ADDENDUM NO. 1

**Administration Building Renovation Re-bid
Compton Community College District**

tBP Project. No. 20987.00

tBP/ARCHITECTURE

1ST FLOOR PLAN
SCALE 1/8" = 1'-0" 1

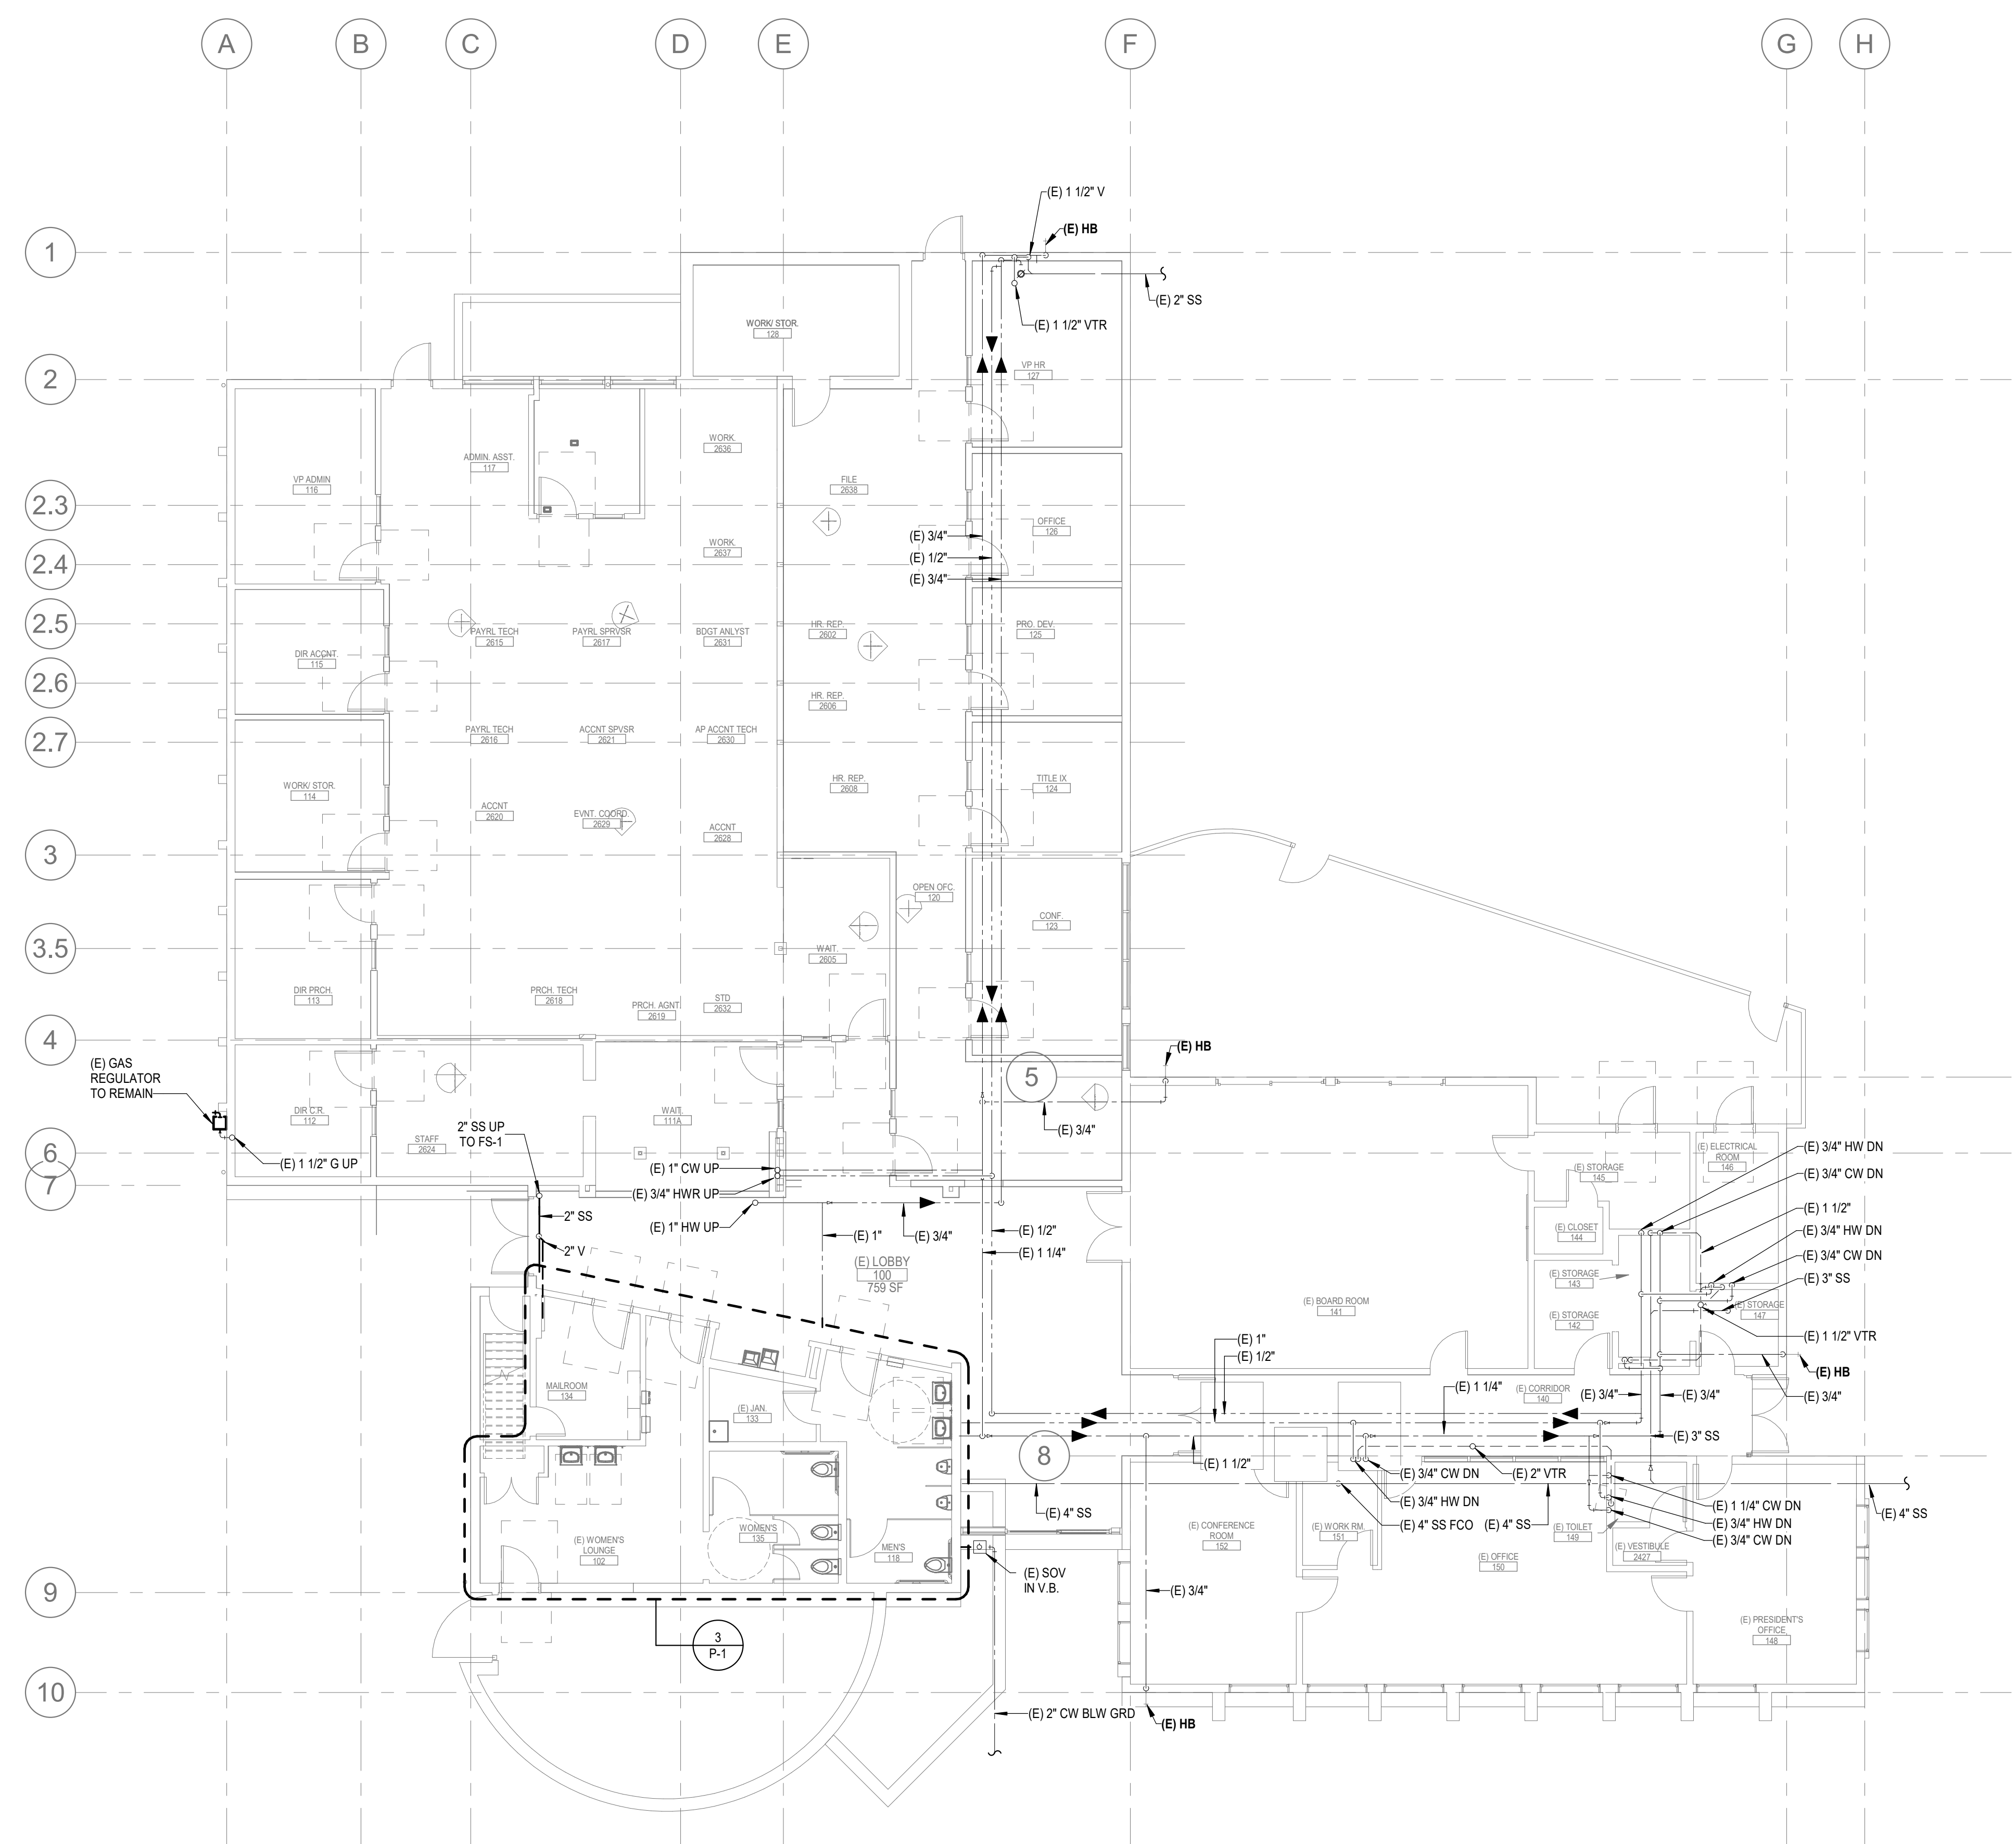
- 21 **Revised Sheet P-1 PLUMBING REMODEL FLOOR PLANS**
- a. Relocated the drinking fountain from the corridor to the vestibule location.
See attached revised Full size sheet identifying revisions included as part of this addendum.

drawing no.:
PD-1
drawing of

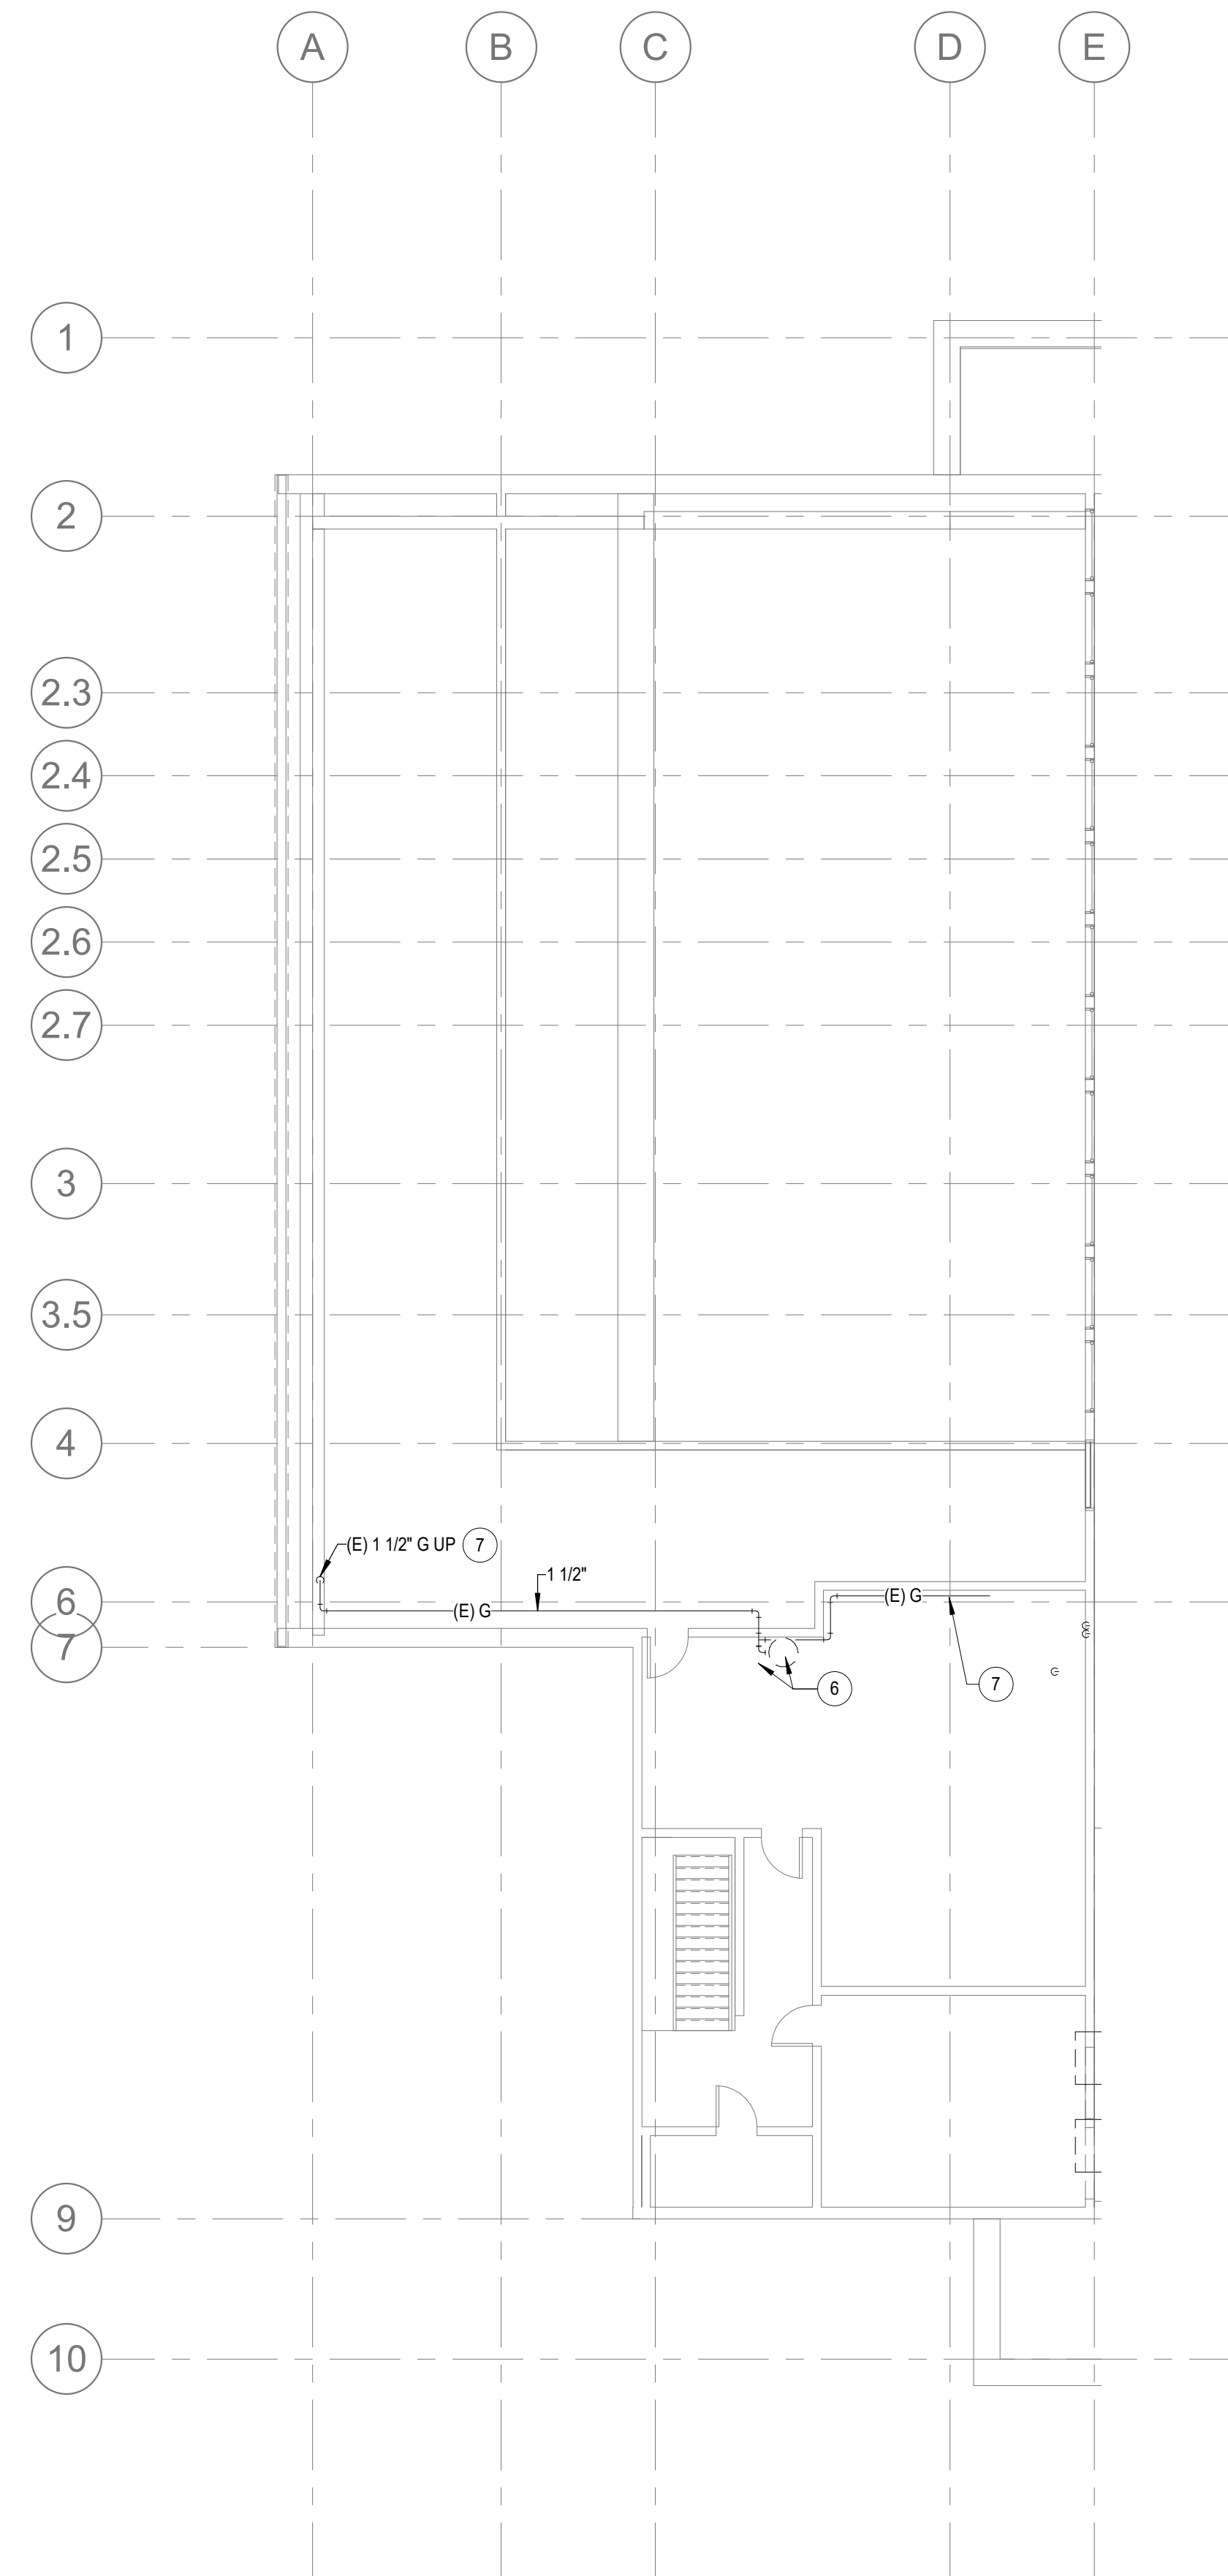
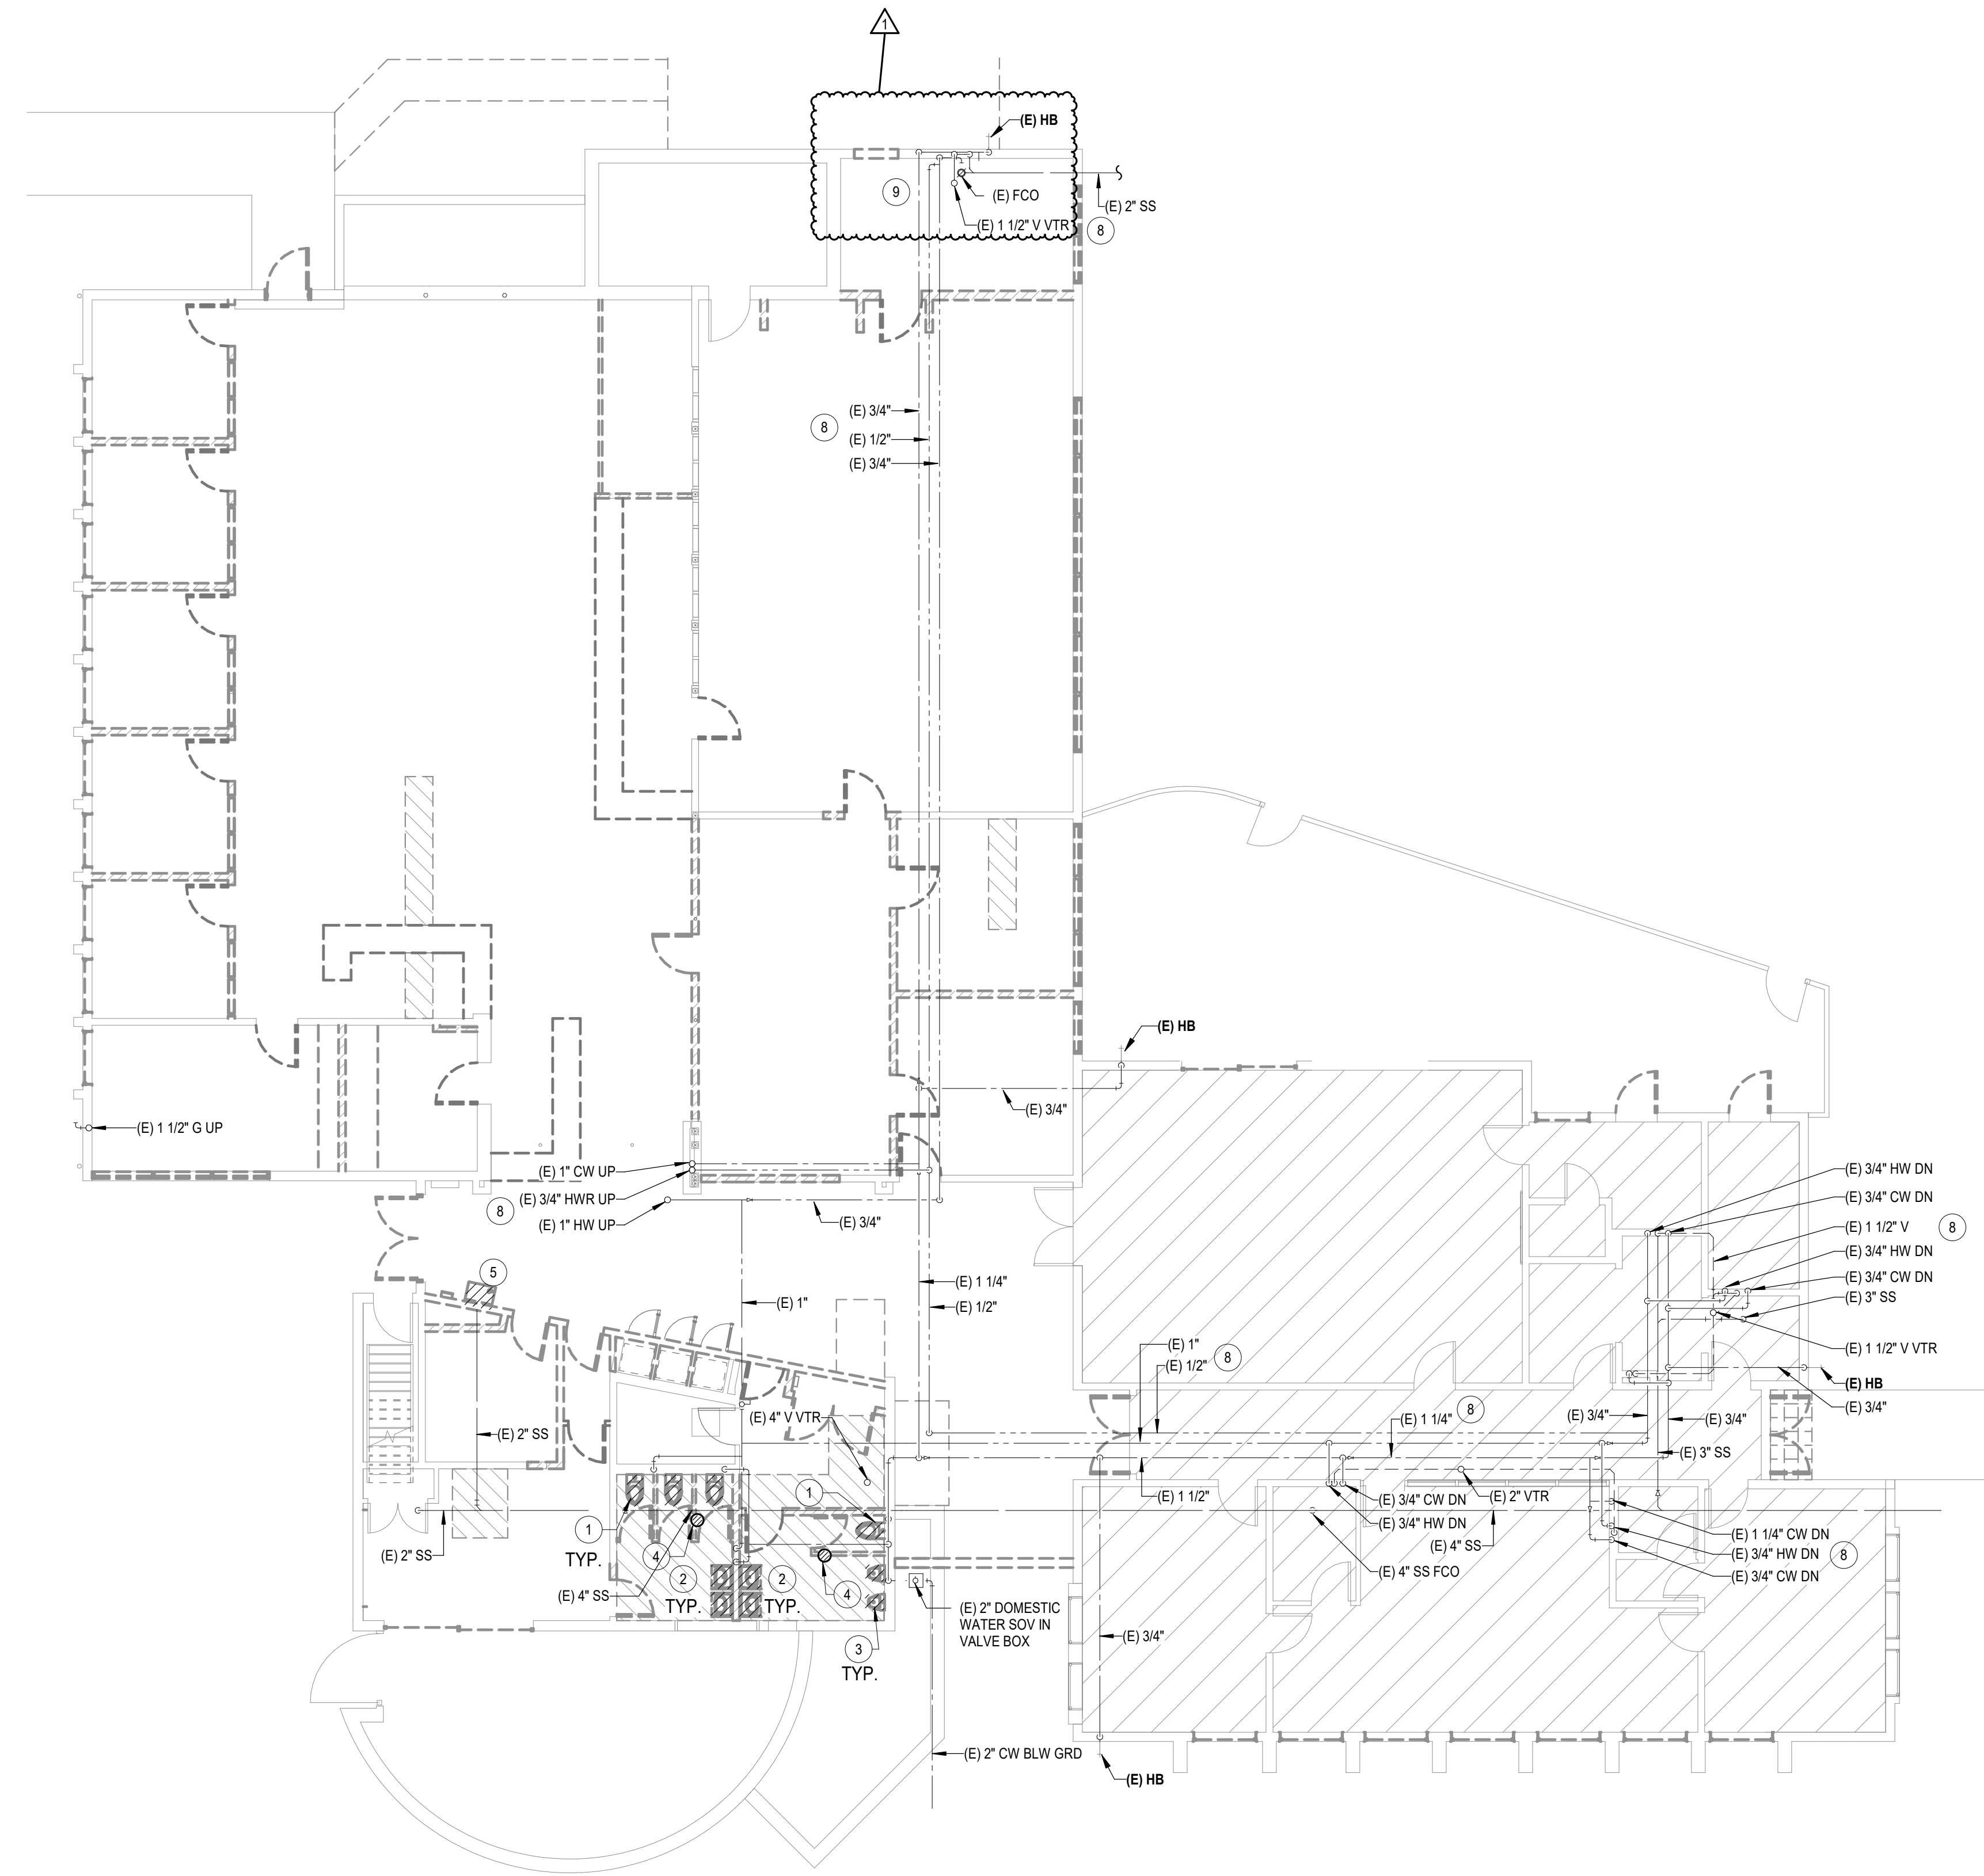
- 22 **Revised Sheet PD1 PLUMBING DEMO PLANS**
- a. Added note to demo existing drinking fountain.
 - b. Added note to demo existing sink.
See attached revised Full size sheet identifying revisions included as part of this addendum.
